**SHINE MEDICAL TECHNOLOGIES, LLC OPERATING LICENSE APPLICATION
SUPPLEMENT NO. 2**

**FINAL SAFETY ANALYSIS REPORT CHANGE SUMMARY
PUBLIC VERSION**

FINAL SAFETY ANALYSIS REPORT MARKUP

Figure 4a2.1-1 – Irradiation Unit Cell Schematic

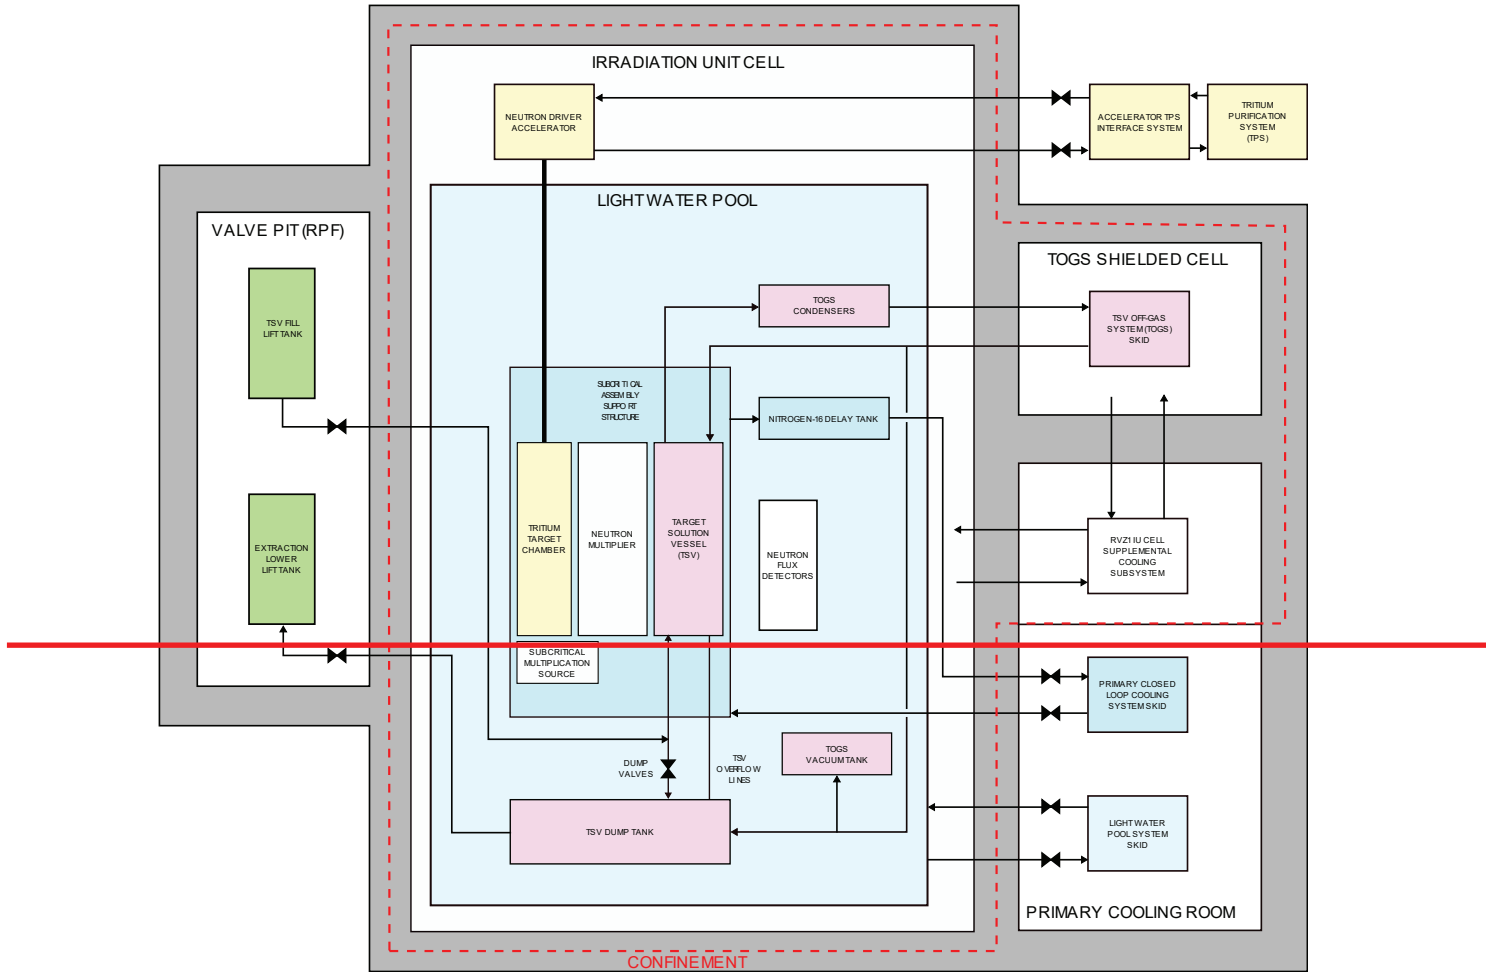
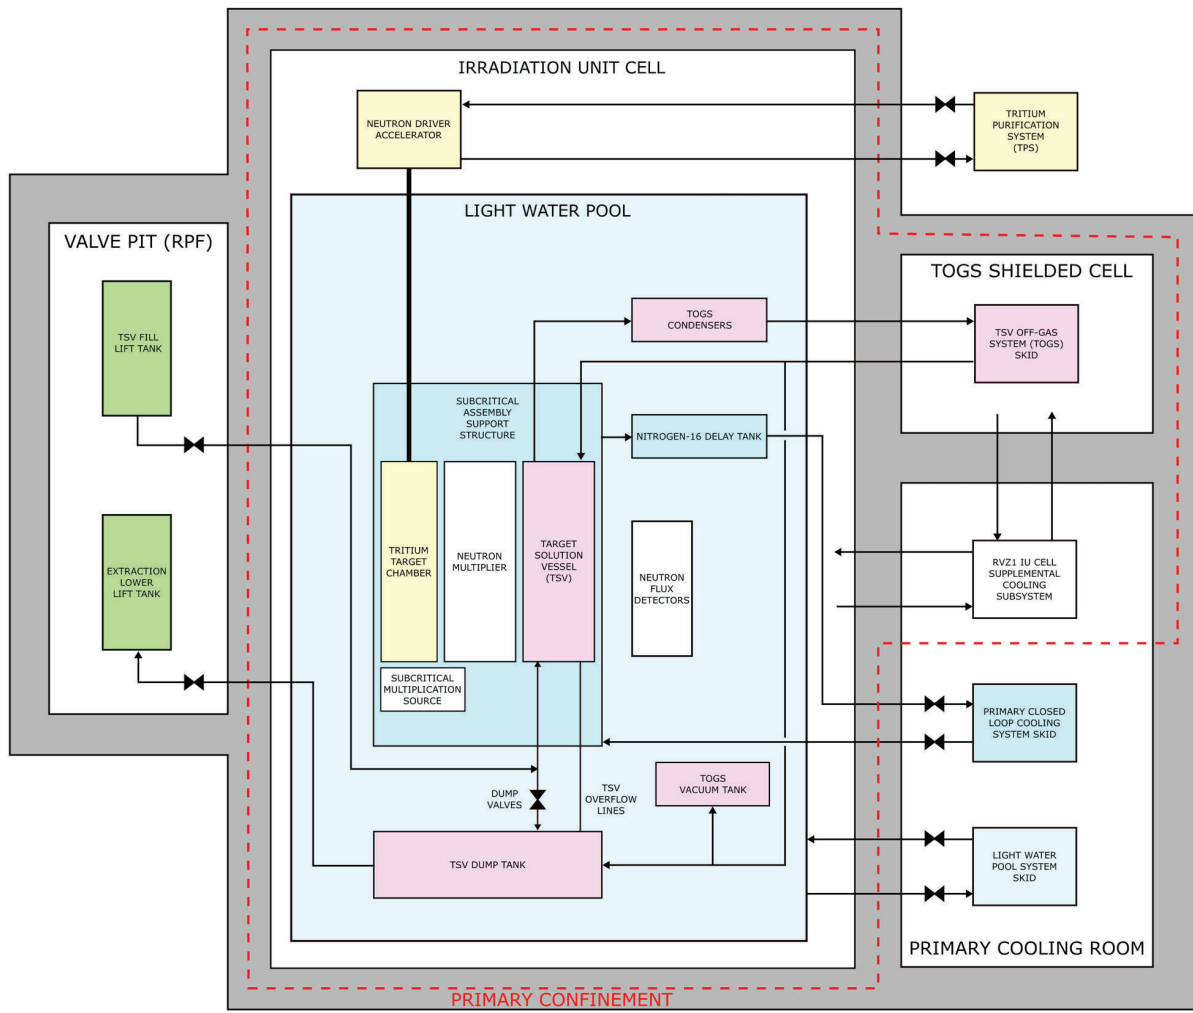
- Tritium purification system (TPS): The TPS is located outside the IU cell except for lines interfacing with the NDAS. The neutron driver is connected to the ~~common~~-tritium system by supply and return lines that pass through the IU cell shield wall. During operation, purified tritium gas is supplied to the tritium target chamber, ~~purified~~-deuterium gas is

Figure 5a2.2-1 – Primary Closed Loop Cooling System Flow Diagram

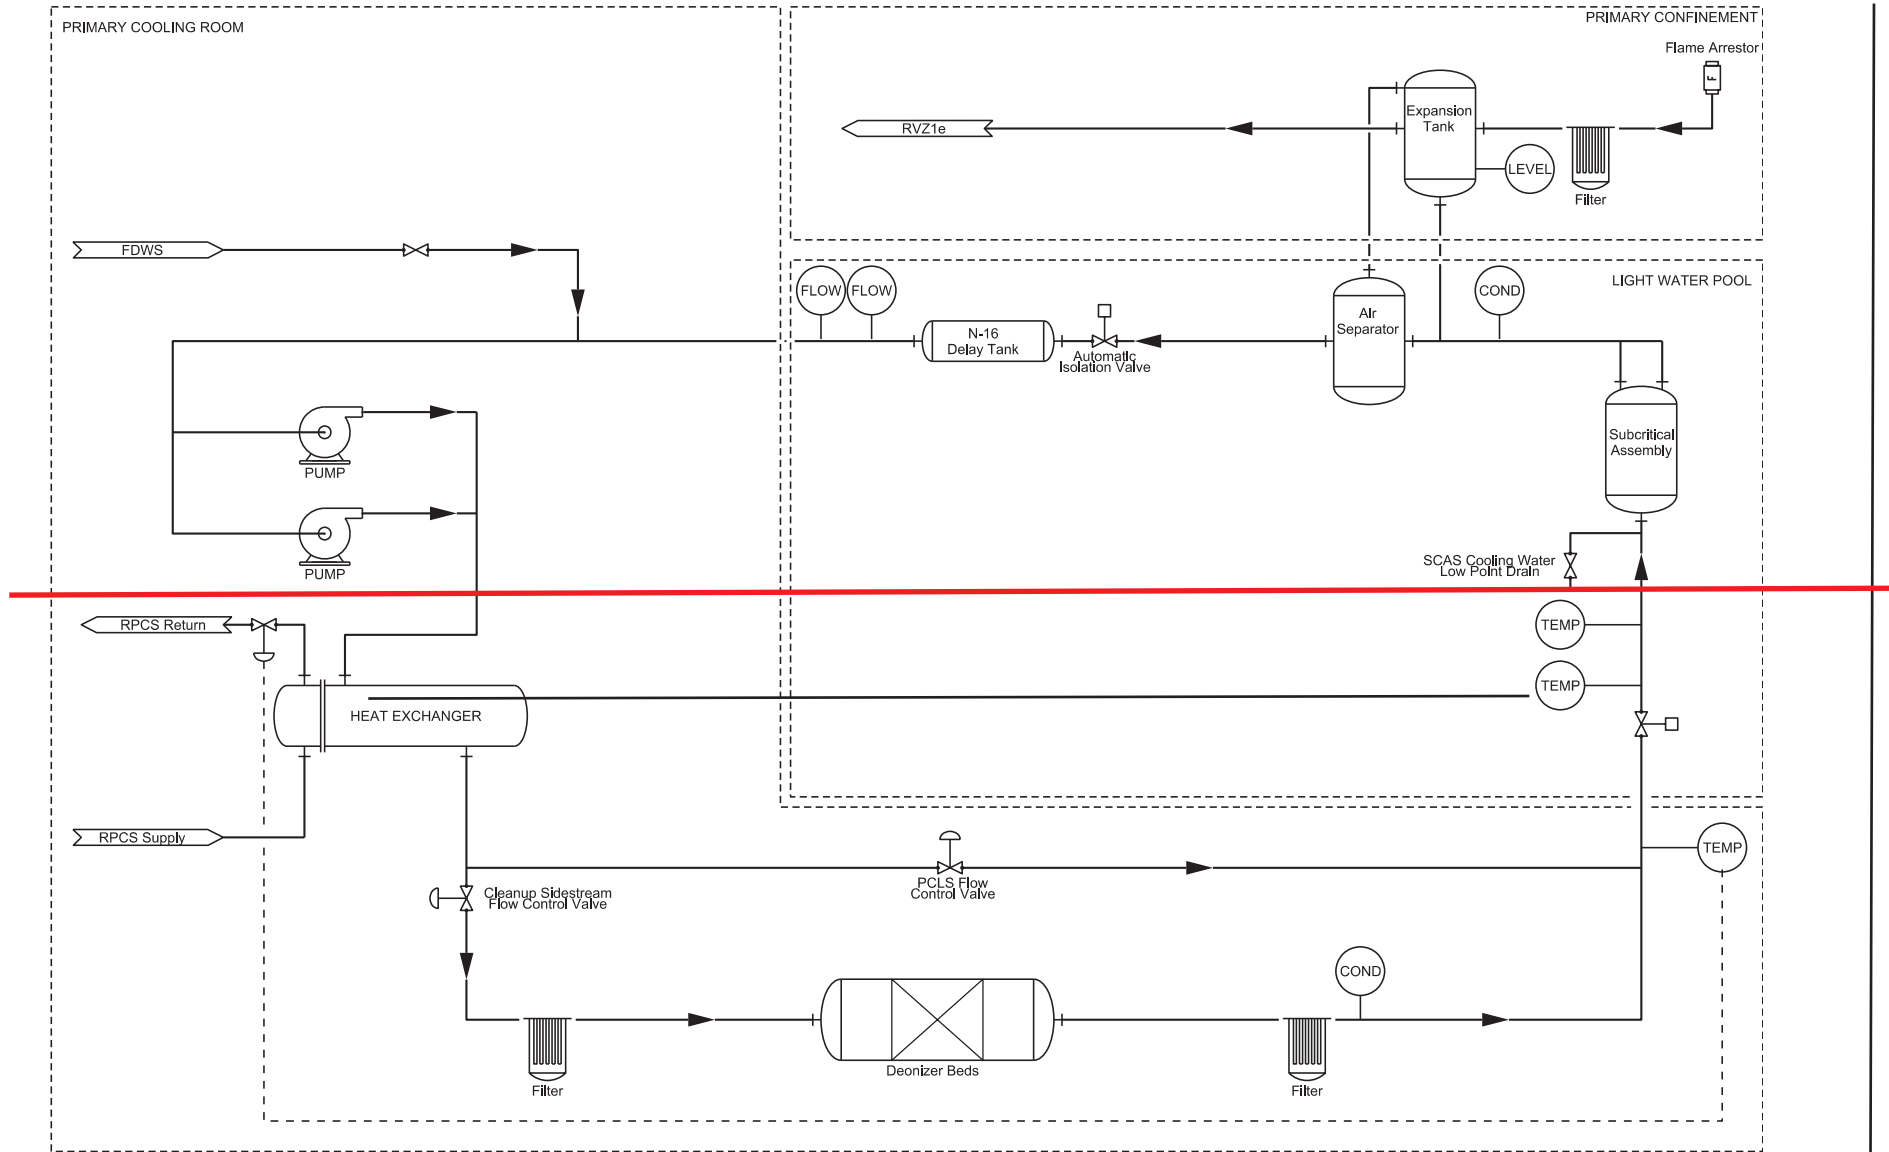
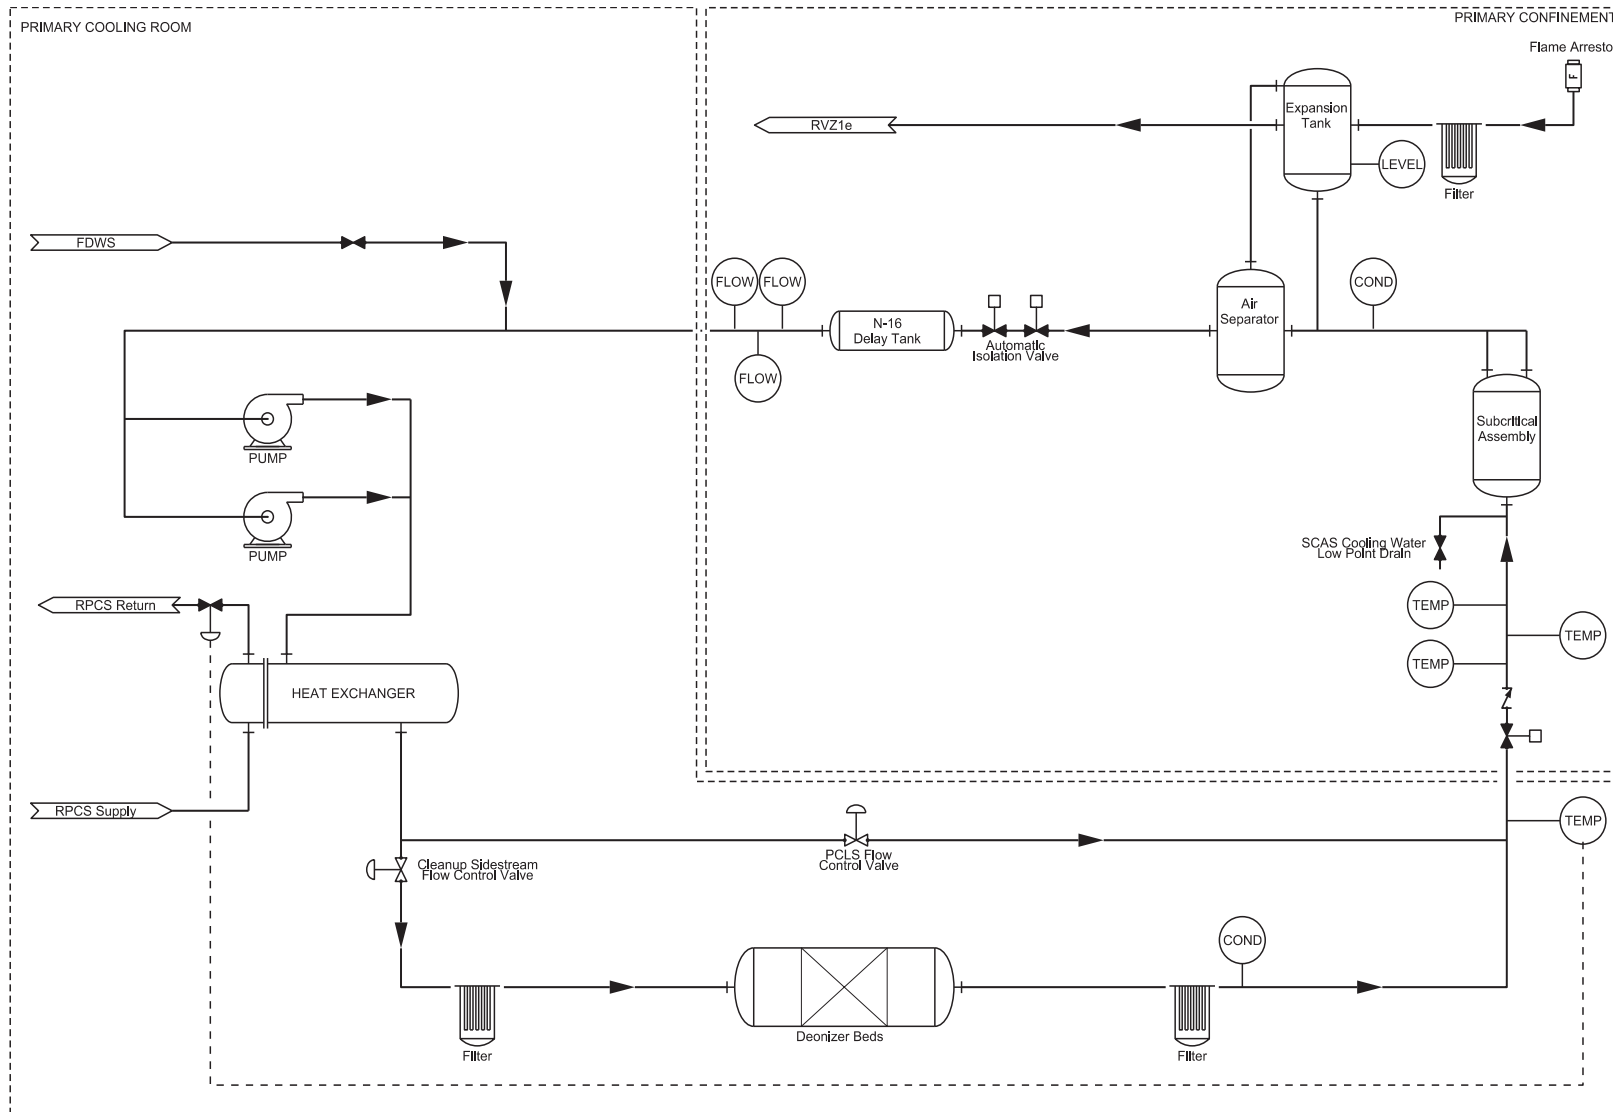
<p>Update to incorporate primary closed loop cooling system (PCLS) design changes. The PCLS design has been updated to incorporate SHINE design criteria 34, confinement isolation. This change improves the reliability of PCLS isolation safety functions.</p>	<p>Table 3.1-1, Section 5a2.2, Figure 5a2.2-1, Section 7.4, Figure 7.4-1</p>

The PCLS piping penetrating confinement boundaries are provided with [redundant](#) isolation capabilities [as shown in Figure 5a2.2-1](#). ~~Piping systems that pass between confinement boundaries are equipped with either:~~
